DART AEROSPACE LTD	Work Order:	98197
Description: Crosstube Assembly, Mid Aft	Part Number:	D206-667-247TRN
Inspection Dwg: D206-667-247 Rev: A		Page 1 of 2

DRAWING NO. D206-667-247
REV. A
SHEET 1 OF 4

TITLE CROSSTUBE ASS'Y (206L MID AFT)
SCALE NTS

DRAWING NO. D206-667-247	TITLE CROSSTUBE ASS'Y (206L MID AFT)	REV. A	DART AEROSPACE LTD ENGINEERING ORDER		D.E.O. NO. D206-667-247-A-1	SHEET NO. SHEET 1 OF 1	SCALE NTS
DRAWN JP	CHECKED ASS	MFG. APPR. KS	APPROVED JMD		DE APPR. H		
DATE 11.07.15	DATE 11.07.20	DATE 11.07.21	DATE 11/07/21		DATE 11.07.21

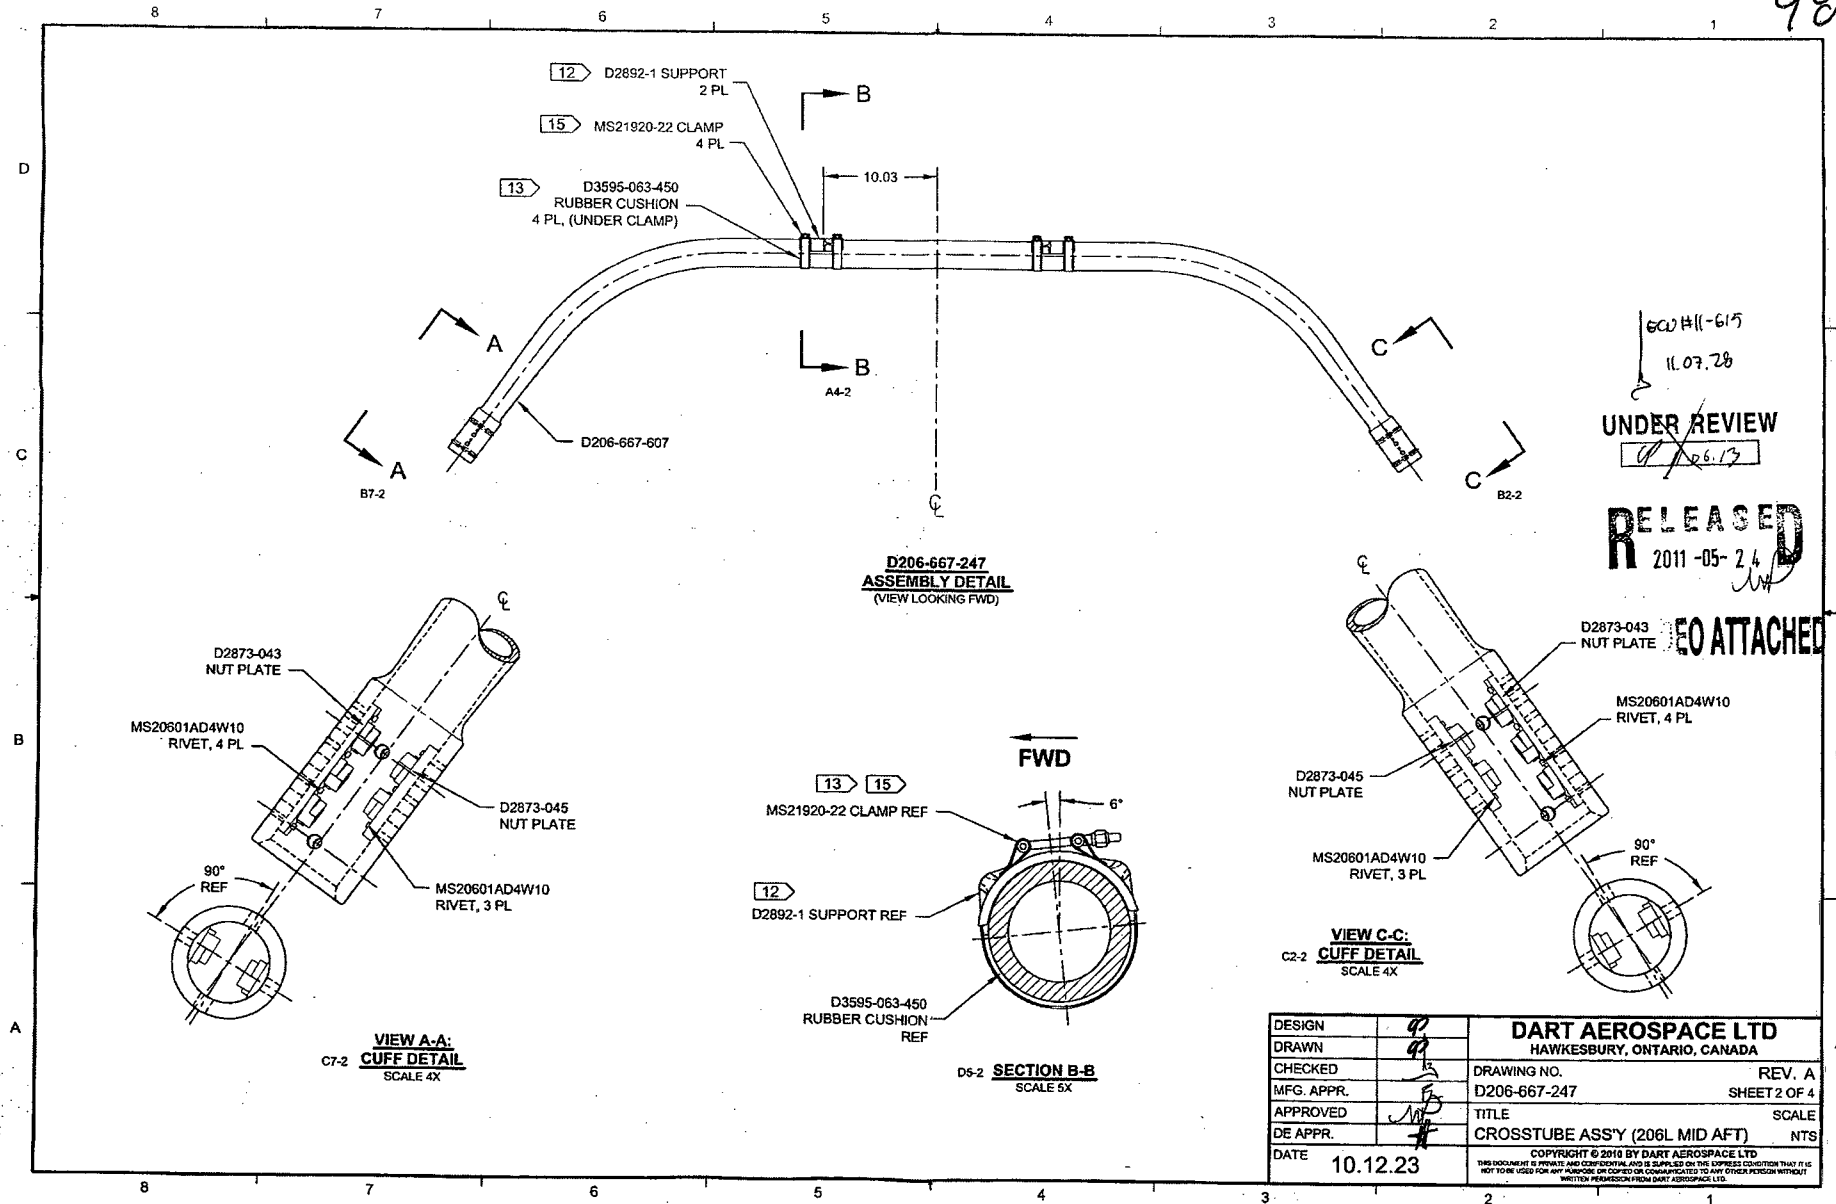
PURPOSE:

REPLACE MAGNOBOND WITH PROSEAL

NOTE 12 & 15, SHEET 1 IS AMENDED AS FOLLOWS:

Item	Qty -247	Part Number	Description
9	A/R	PROSEAL 890 B-2	SEALANT, AMS-S-8802 CLASS B-2

- 12) TO INSTALL D2892-1 SUPPORT: ABRASE MATING SURFACE OF SUPPORT AND CROSSTUBE WITH 180-GRIT SANDPAPER AND REMOVE RESIDUE WITH MEK (OR EQUIVALENT). APPLY A 0.04" TO 0.07" THICK LAYER OF PROSEAL 890 CLASS B-2 (OR AMS-S-8802 CLASS B-2) SEALANT TO MATING SURFACE OF SUPPORT.
- 15) TORQUE CLAMPS 80 TO 100 IN.-LB. ENSURE AT LEAST 1.5 THREADS SHOWING IN SAFETY AND THAT NUT HAS NOT BOTTOMED-OUT AFTER TORQUING. **PRIOR TO PACKAGING, RE-CHECK TORQUE ON CLAMPS AFTER PROSEAL 890 SEALANT HAS CURED FOR 72 HOURS.**
